SEWAGE DISPOSAL SYSTEM
HOWARD COUNTY HEALTH DEPARTMENT
BUREAU OF ENVIRONMENTAL HEALTH
410-313-2640

P 514988-D
A 37508
ISSUE DATE 3/19/2001
APPROVAL DATE 6/29/01

ADDRESS 13785 Burntwoods Road, Glenelg, MD 21737 PHONE 301-854-6172
SUBDIVISION Chapel Woods II LOT NUMBER 11 ADDRESS 11828 Chapel Estates Drive
PROPERTY OWNER Jonathan Schultz PROPERTY OWNER'S ADDRESS 6324 Angel Rose Court
SEPTIC TANK CAPACITY 1500 GALLONS
PUMP CHAMBER CAPACITY 1500 GALLONS
NUMBER OF BEDROOMS 5
SQUARE FEET PER BEDROOM 180
LINEAR FEET OF TRENCH REQUIRED 300

514988-D

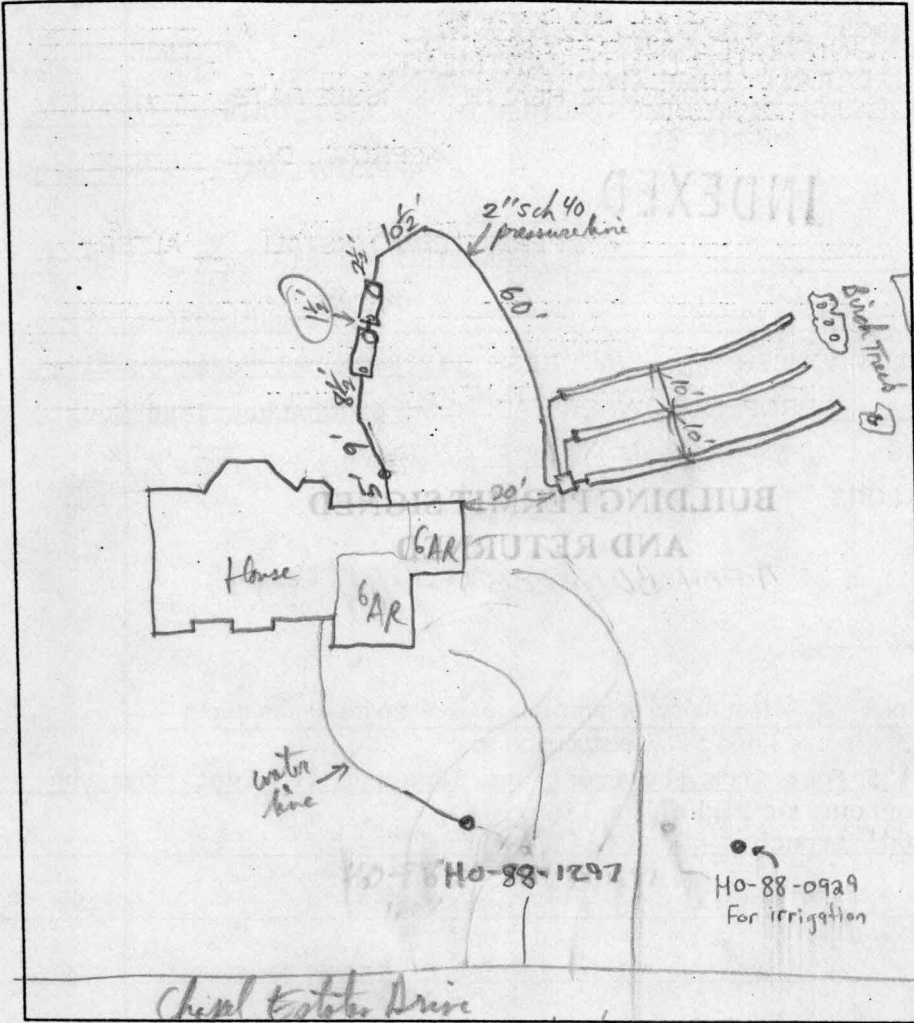
6/4/01 SPECS MODIFIED DUE TO 2 1/2 CUT @ SRA COR NEAR HOUSE (MR)

PRE-CONSTRUCTION INSPECTION: 6/4/01 SMALL PART OF SRA NEAR HOUSE

CUT ~ 2 1/2'; SPECS CHANGED ACCORDINGLY. OK TO START PER PLAN (MR)

INSPECTION COMMENTS: Trenches complete & OK to cover, Pump chamber & ST Baffle + riser OK (consult to lids of tanks), House Connection OK. HOLD - PUMP INSP. P/P 6/15/01

Alarm & pump floats work OK, rechecked to good tolerance flow in dist Box. OK to cover all work. P/P 6/29/01

TRENCHES: Trenches to be 3 feet wide. Inlet 2 1/3 feet below original grade. Bottom maximum depth 45 feet below original grade. 2 feet of stone below distribution box.
LOCATION: Start the first trench 125 feet from the front lot line and 110 feet from the right lot line. Run trenches on contour to right lot line.
Required Layout: (3) 100' trenches 10/24/00 O.K. (MR)
